ADDENDUM NO. 2

DATE: February 9, 2026

Project: Glenview Public Library
Study Room Renovation

Project No.: 25008

A2.20

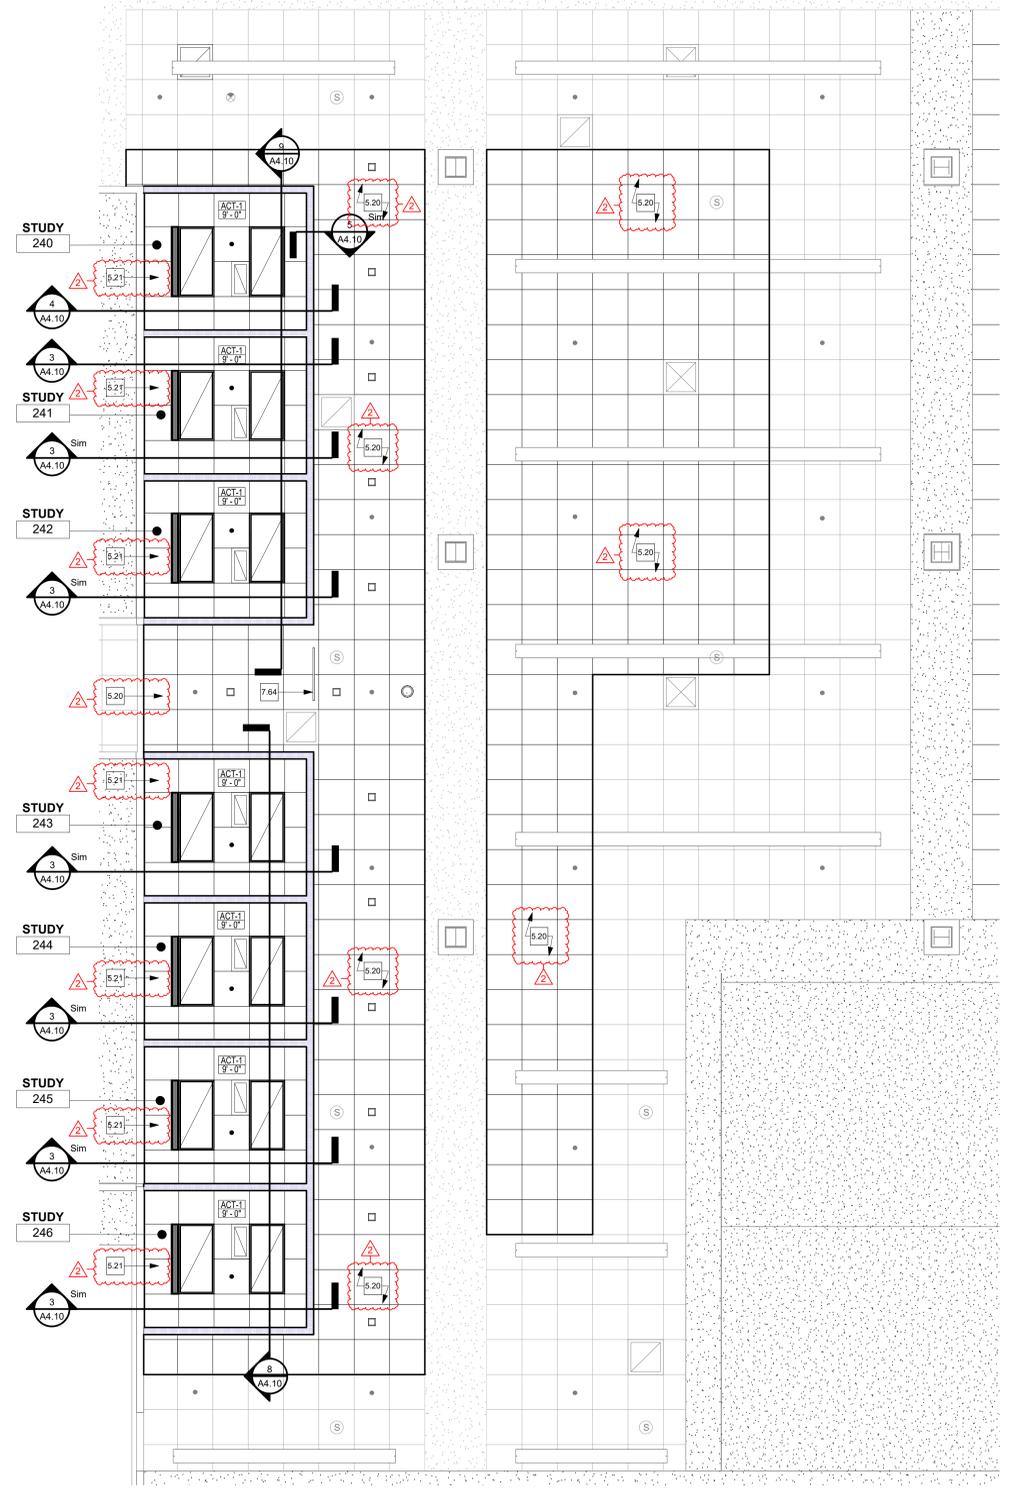
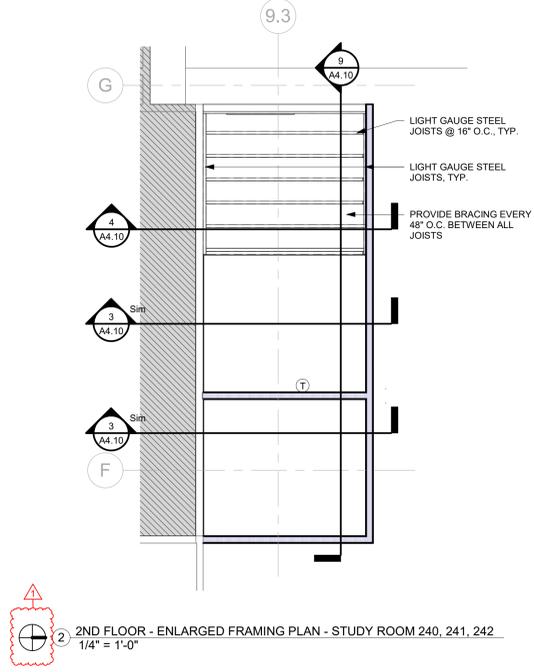
- A. Sheet T1.00 – Title Sheet
 - 1. Revise drawing index per resubmitted sheet
- B. Sheet A2.20
 - 1. Add new work sheet note 5.20 and 5.21 per resubmitted sheet

5.20 CONTRACTOR TO REINSTALL EXISTING ACOUSTICAL CEILING TILES AND ANY AFFECTED LIGHTING FIXTURES, HVAC GRILLES, LIFE SAFETY DEVICES, AND ANY OTHER CEILING-MOUNTED ACCESSORIES INTO EXISTING ACOUSTICAL CEILING GRID SYSTEM ONCE ALL MECHANICAL, ELECTRICAL, AND FIRE PROTECTION WORK HAS BEEN COMPLETED. REPLACE ANY DAMAGED CEILING TILES WITH OWNER'S ATTIC STOCK.

5.21 CONTRACTOR TO PROVIDE AND INSTALL NEW ACOUSTICAL CEILING GRID SYSTEM TO MATCH EXISTING. CONTRACTOR TO UTILIZE AND REINSTALL EXISTING SALVAGED ACOUSTICAL CEILING TILES. REPLACE ANY DAMAGED CEILING TILES WITH OWNER'S ATTIC STOCK.
